COUNTY OF ORANGE, OC PUBLIC WORKS DEPARTMENT

Revision: August 2018

SPPWC STANDARD PLAN - ELECTRICAL SERVICE

501-3
SHEET 1 OF 3

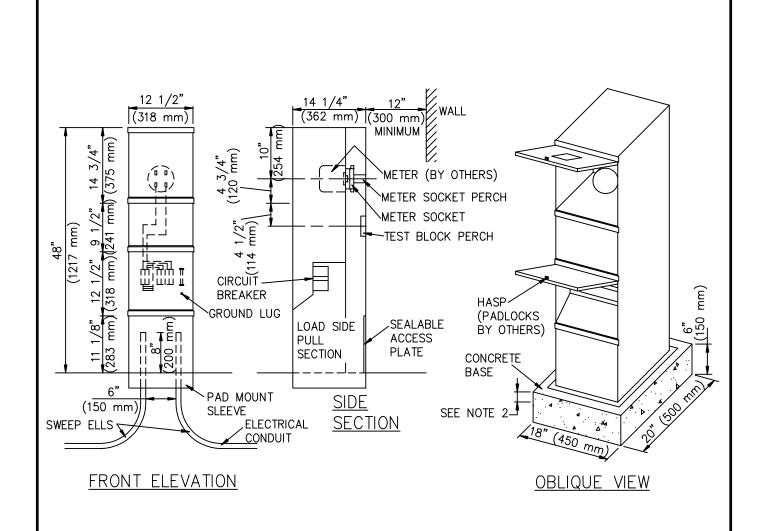
- 1. DELETE SCHEDULE 40 GALVANIZED STEEL AT POWER POLE. ADD SCHEDULE 80 PVC.
- 2. ADD APPROVED TO WATERPROOF CONNECTION.
- 3. DELETE SCHEDULE 40 GALVANIZED STEEL AT SWEEP ELL. ADD SCHEDULE 40 PVC.
- 4. DELETE COPPER BONDING STRAP.
- 5. PLASTIC BOX MAY BE SUBSTITUTED IN PLANTING AREAS NOT IMMEDIATELY ADJACENT TO OR IN CONCRETE.

502-3
SHEET 1 OF 1

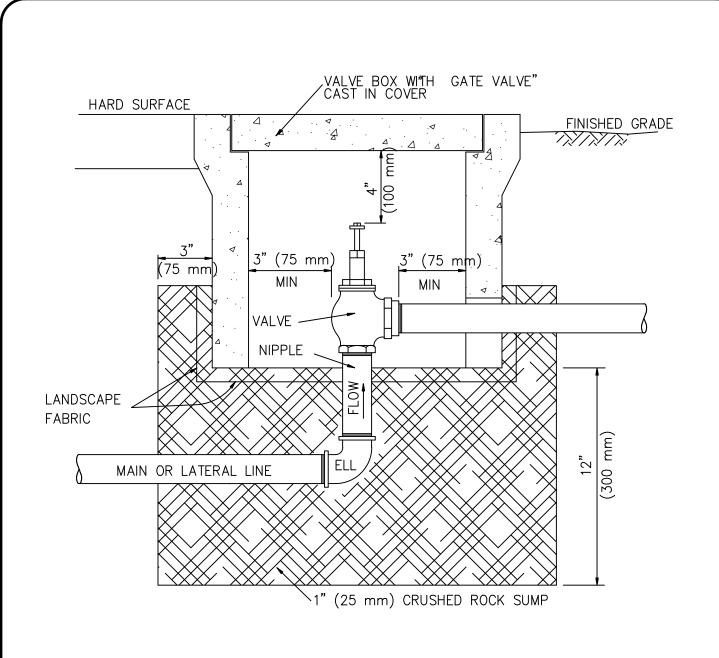
- USE CLASS 315 PVC PIPE AND SCHEDULE 40 PVC FITTINGS FOR 2 INCHES OR GREATER. USE SCHEDULE 40 PVC PIPE AND FITTINGS FOR SIZES 1½ INCHES OR LESS.
- 2. PROVIDE TWO OPERATING KEYS FOR VALVES.
- 3. <u>FOR TURF AREAS</u> ALL ANGLE VALVES SHALL BE LOCATED OUTSIDE THE DESIGNATED PLAYING FIELD (I.E., BALL DIAMOND, SOCCER, ETC.).
- 4. VALVES UP TO 2 INCHES IN DIAMETER SHALL HAVE MALLEABLE IRON "TEE" HANDLES. VALVES LARGER THAN 2 INCHES IN DIAMETER SHALL HAVE SQUARE OPERATING NUTS.
- 5. VALVE BOX SHALL BE ONE OF THE FOLLOWING CASES AS SPECIFIED ON THE PLANS:
  - CASE 1. CONCRETE BOX W/CONCRETE COVER
  - CASE 2. CONCRETE BOX W/LOCKING CAST IRON COVER
  - CASE 3. PLASTIC BOX W/LOCKING PLASTIC COVER
- 6. WRAP LANDSCAPE FABRIC AROUND SIDES AND BOTTOM OF BOX TO COVER ALL OPENINGS.

STANDARD PLAN
505-3

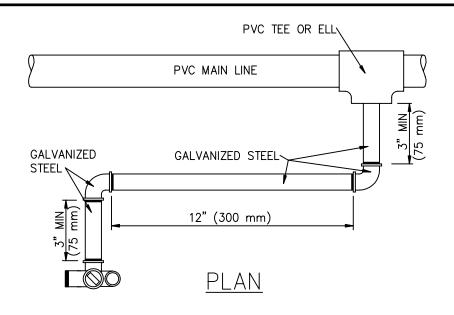
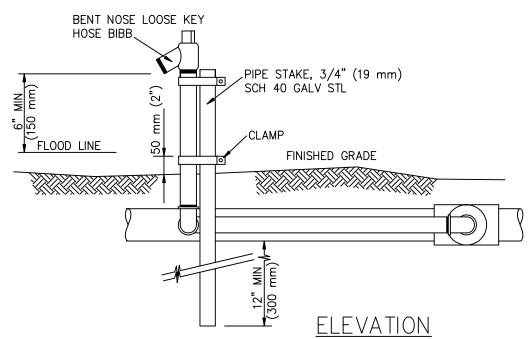
- 1. HOSE BIBB VALVE SHALL BE BRASS.
- 2. FOR TURF AREAS ALL HOSE BIBB VALVES SHALL BE LOCATED OUTSIDE THE DESIGNATED PLAYING AREA (I.E., BALL DIAMOND, SOCCER FIELD, ETC.).
- 3. REVISE NOTE 5 TO READ: SCHEDULE 80 PVC RISERS, FITTINGS AND SCHEDULE 40 ULTRAVIOLET RESISTANT PVC PIPE ARE APPROVED FOR ABOVE GROUND INSTALLATION.

506-3

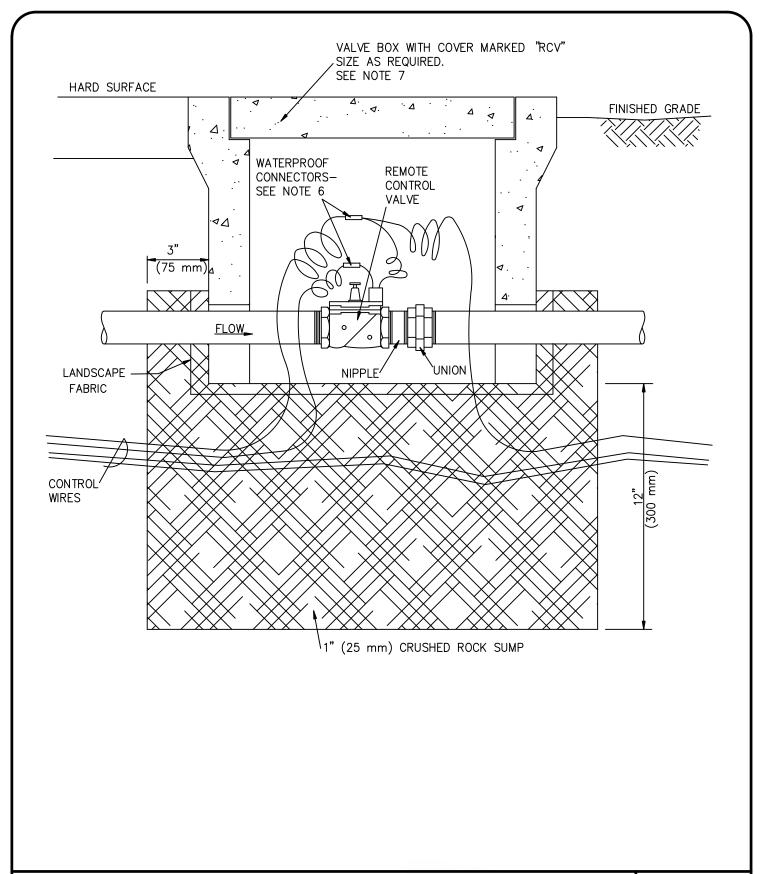
- USE CLASS 315 PVC PIPE AND SCHEDULE 40 PVC FITTINGS FOR SIZES 2 INCHES OR GREATER. USE SCHEDULE 40 PVC PIPE AND FITTINGS FOR SIZES 1 INCHES OR LESS.
- 2. PROVIDE ONE CONTROLLER VALVE ID TAGS PER VALVE. ID TAGS SHALL BE POLYURETHANE 2¼ INCHES X 2¾ INCHES MINIMUM WITH 1½ INCHES BLOCK LETTERS ON A CONTRASTING BACKGROUND.
- 3. ALL REMOVE CONTROL VALVES AND ENCLOSURES SHALL BE LOCATED OUTSIDE OF DESIGNATED PLAYING FIELD (I.E., BASEBALL, SOCCER, ETC.).
- 4. DISTANCE BETWEEN BOTTOM OF VALVE BOX COVER AND TOP OF VALVE SHALL BE 4 INCHES.
- 5. WRAP LANDSCAPE FABRIC AROUND SIDES AND BOTTOM OF BOX TO COVER ALL OPENINGS.

507-3

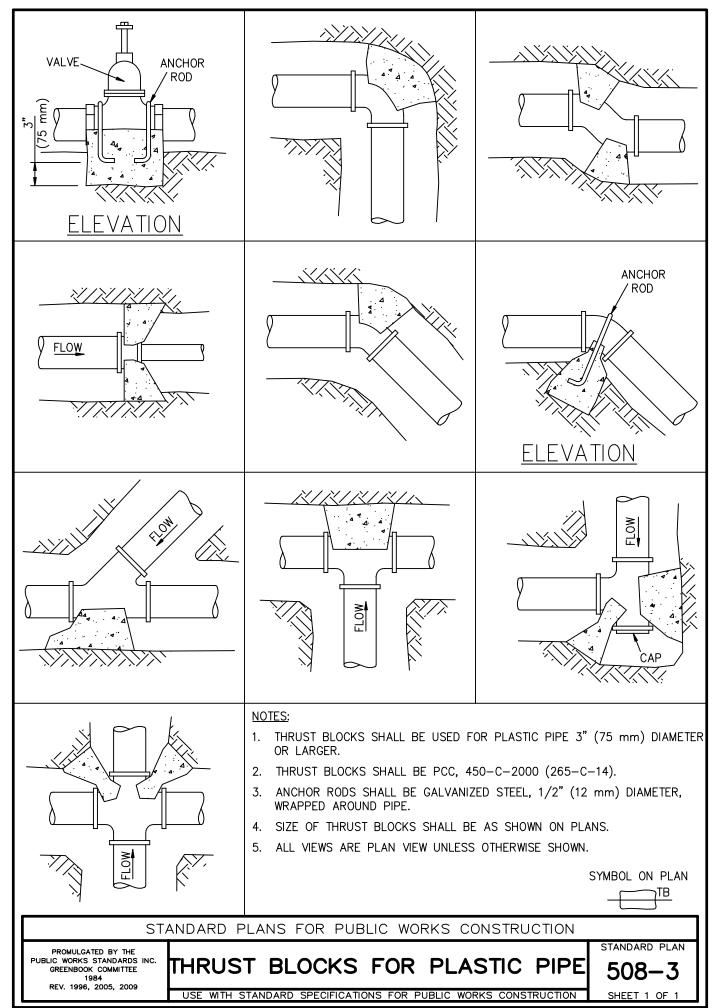
- USE CLASS 315 PVC PIPE AND SCHEDULE 40 PVC FITTINGS FOR SIZE 2 INCHES OR GREATER. USE SCHEDULE 40 PVC PIPE AND FITTINGS FOR 1 SIZES 1 INCHES OR LESS. 2
- 2. PROVIDE ONE CONTROLLER VALVE IDENTIFICATION TAG PER VALVE. ID 1 3 1 TAGS SHALL BE POLYURETHANE 2 INCHES X 2 INCHES WITH 1 4 4 8 INCHES BLACK LETTERS ON A CONTRASTING BACKGROUND.
- 3. ALL REMOTE CONTROL VALVES WITH QUICK COUPLER AND ENCLOSURES SHALL BE LOCATED OUTSIDE OF DESIGNATED PLAYING FIELD (I.E., BASEBALL DIAMOND, SOCCER FIELD, ETC.).
- 4. DISTANCE BETWEEN BOTTOM OF VALVE BOX COVER AND TOP OF VALVE SHALL BE 4 INCHES.

5. QUICK COUPLER SHALL HAVE LOCKING.

STANDARD PLAN
510-3

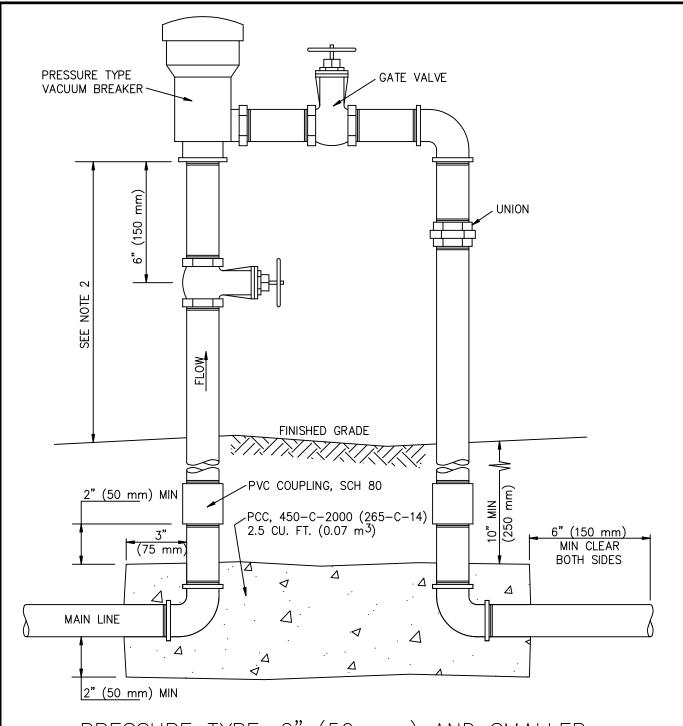
1. REVISE NOTE 1 TO READ: RISER PIPES AND FITTINGS SHALL BE BRASS.

512-3

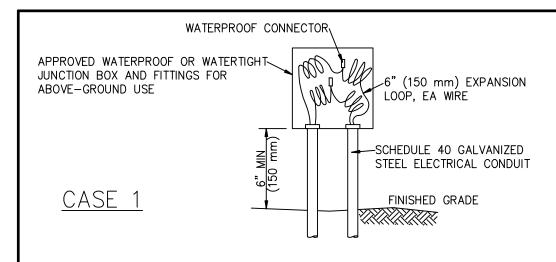
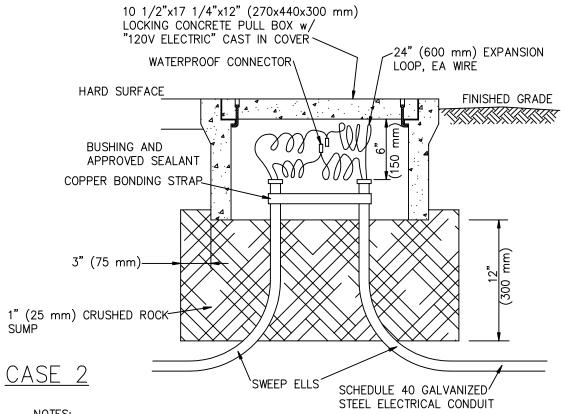
1. REVISE NOTE 1 TO READ: RISER, PIPES AND FITTINGS SHALL BE BRASS.

2. ADD TO NOTE 2: UNLESS OTHERWISE NOTED.

# ELECTRICAL PULL BOX

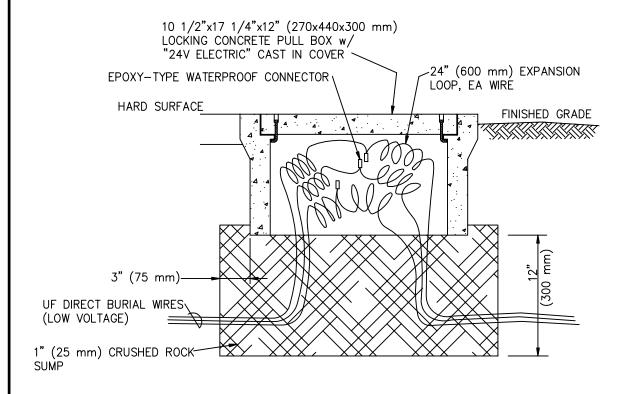
DELETE SCHEDULE 40 GALVANIZED STEEL AND REPLACE WITH SCHEDULE 80 PVC.

- 1. DELETE COPPER BONDING STRAP.
- 2. DELETE SCHEDULE 40 GALVANIZED STEEL AND REPLACE WITH SCHEDULE 40 PVC.
- 3. ADD APPROVED TO WATERPROOF CONNECTOR.
- 4. ADD 120 VOLTS TO HIGH VOLTAGE INSTALLATION TITLE.

514-3 514-3-OC IRRIGATION CONTROLLER ENCLOSURE

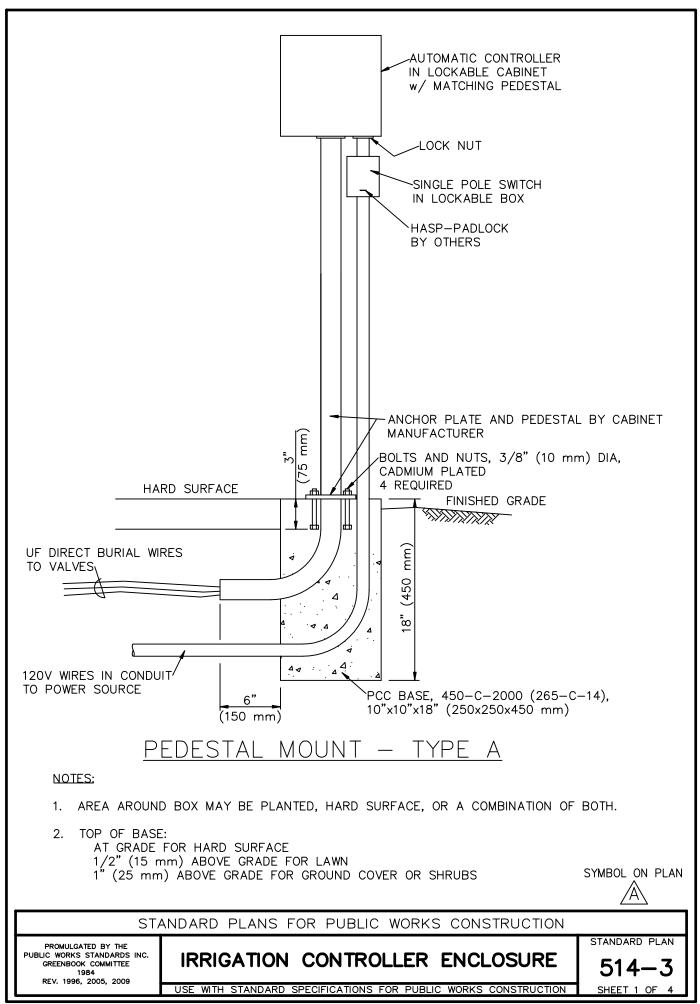
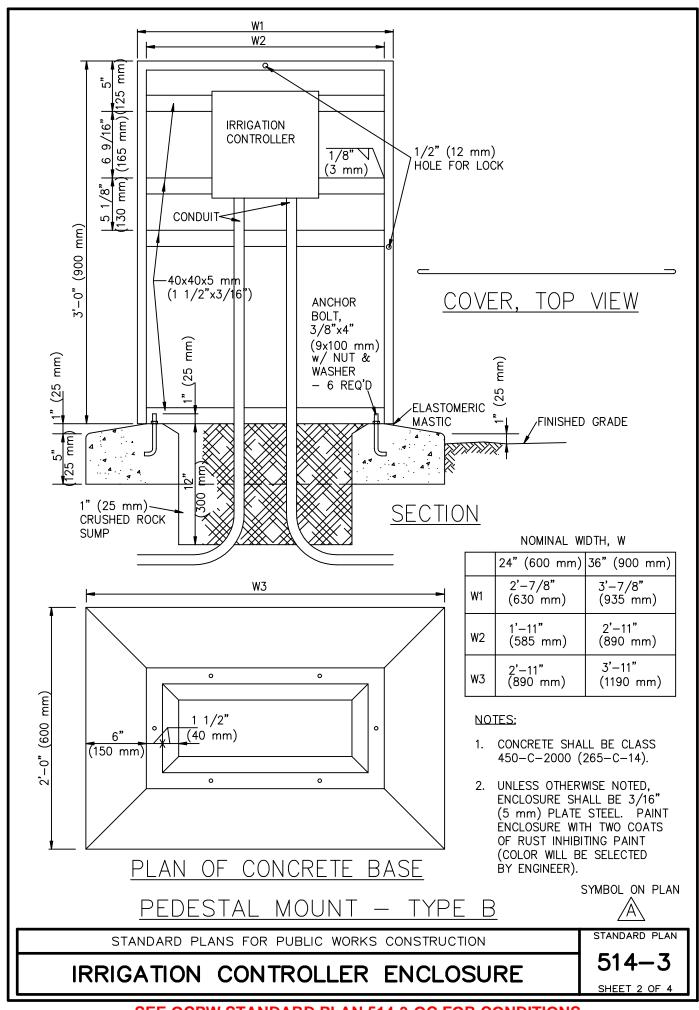
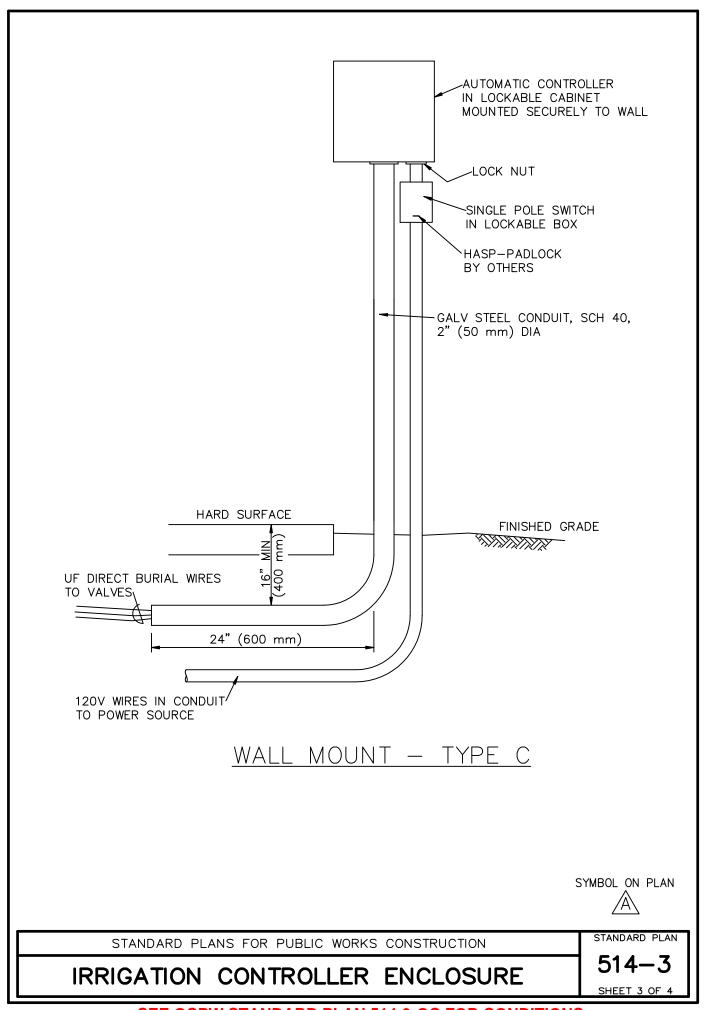
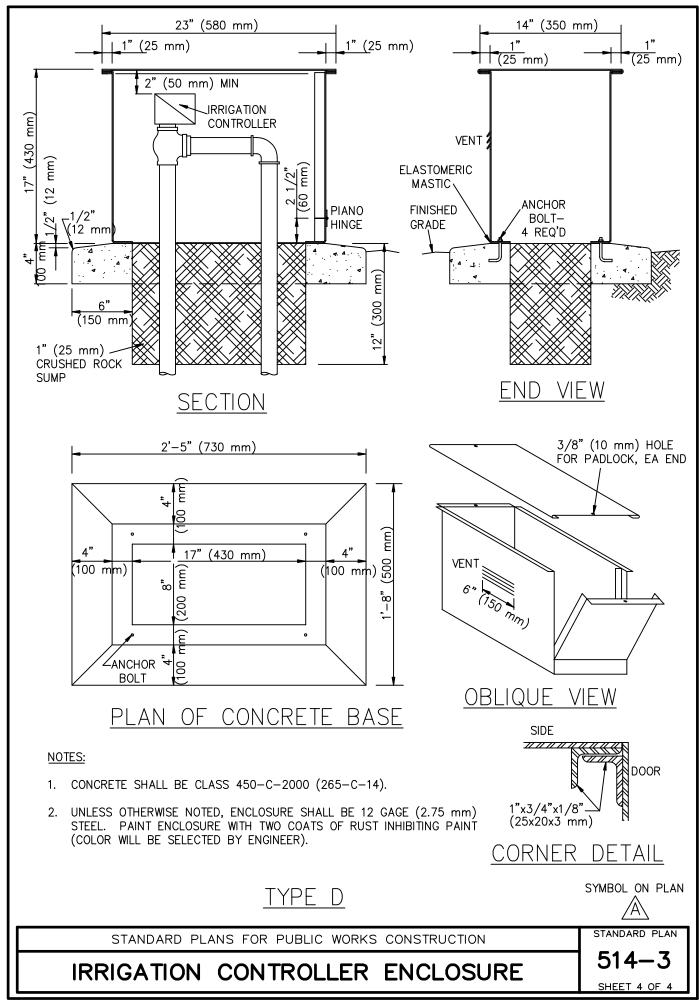
- 1. PEDESTAL MOUNT TYPE A IS NOT ALLOWED.
- 2. PULLBOX FOR DIRECT BURIAL WIRES SHALL BE INSTALLED A MAXIMUM OF 2 FEET FROM FACE OF CONTROLLER.
- 3. PULLBOX SHALL BE TRAFFIC WEIGHT FIBERGLASS WITH HINGED, VANDAL—PROOF, LOCKING COVER MARKED "IRRIGATION—LOW VOLTAGE".

- 1. UF DIRECT BURIAL WIRES TO VALVES SHALL BE BURIED A MINIMUM OF 12 INCHES.
- 2. 120 VOLT WIRES IN ELECTRICAL CONDUIT TO POWER SOURCE SHALL BE BURIED 18 INCHES.
- 3. ADD TO NOTE 1: UNLESS OTHERWISE NOTED.

1. 2 INCH SCHEDULE 40 GALVANIZED STEEL PIPE SHALL READ: 3 INCH GALVANIZED CONDUIT.

1. STAINLESS STEEL MAY BE SUBSTITUTED FOR GALVANIZED STEEL.

518-3
SHEET 1 OF 3

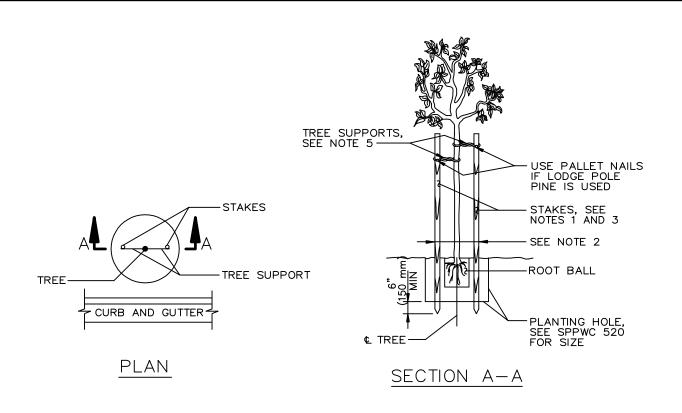
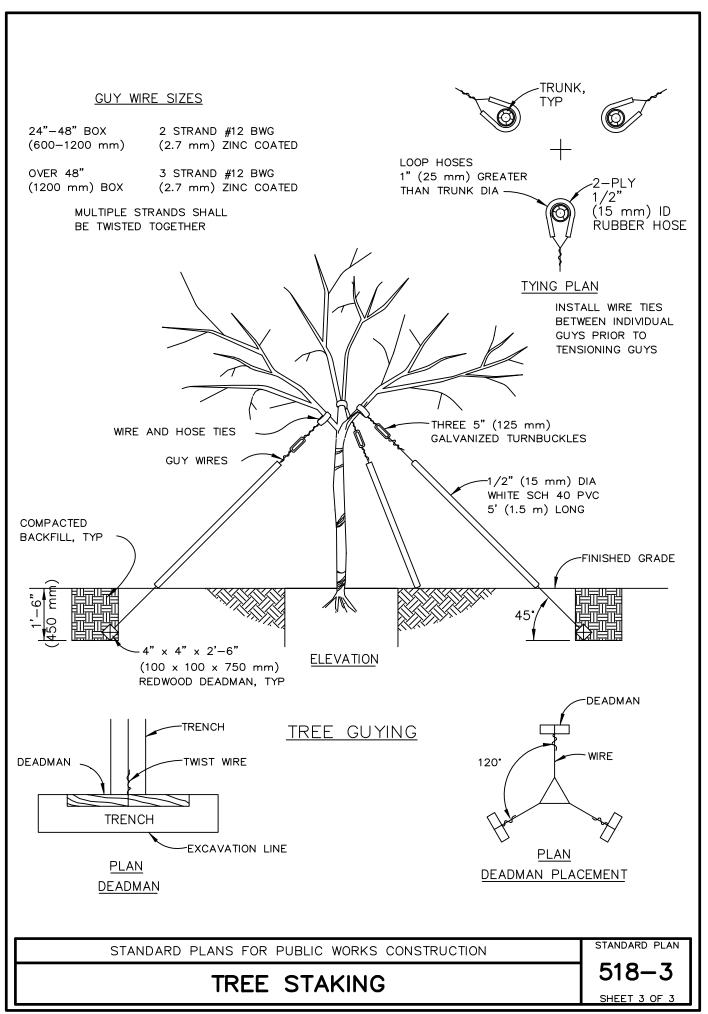
- 1. REVISE NOTE 1 TO READ: STAKE SHALL BE EITHER 2 INCH DIAMETER LODGE POLE PINE, TREATED WITH ALKALINE COPPER QUATERNARY, OR GALVANIZED STEEL PIPE, PER SECTION 308-4.6.1, "METHOD "A" TREE STAKING", OF THE GREENBOOK.
- 2. DELETE NOTE 2 SHEET 1 AND NOTE 3 SHEET 2 AND REPLACE WITH: STAKE SHALL BE HIGH ENOUGH TO KEEP TREE FROM FALLING OVER, HOWEVER IT SHALL NOT BE HIGHER THAN THE TOP OF THE TREE, NOR RUB AGAINST ANY PART OF THE TREE. STAKE SHALL BE INSTALLED OUTSIDE ROOT BALL.
- 3. DELETE "LENGTH OF STAKES" CHART ON SHEET 2. SEE NOTE 2 ABOVF.

519-3

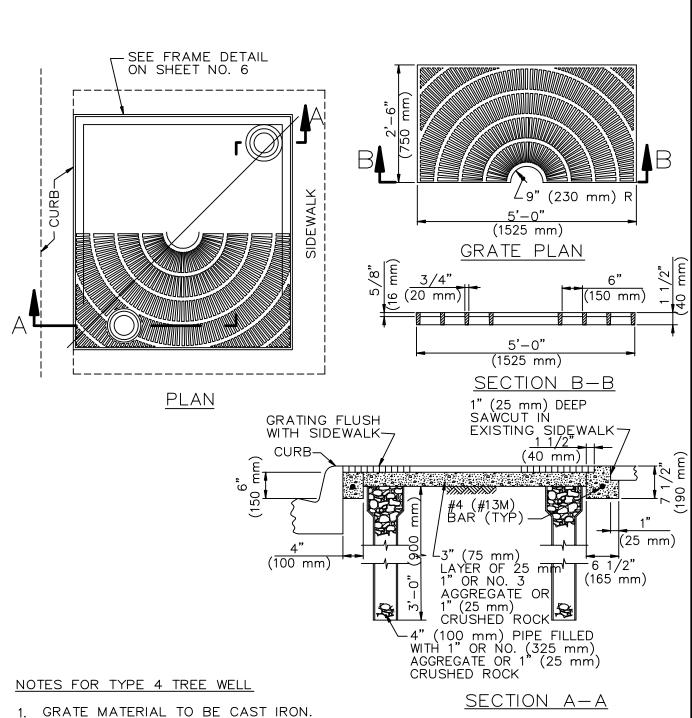
1. REVISE CONCRETE MINIMUM COMPRESSIVE STRENGTH OF 1,200 PSI TO 2,000 PSI.
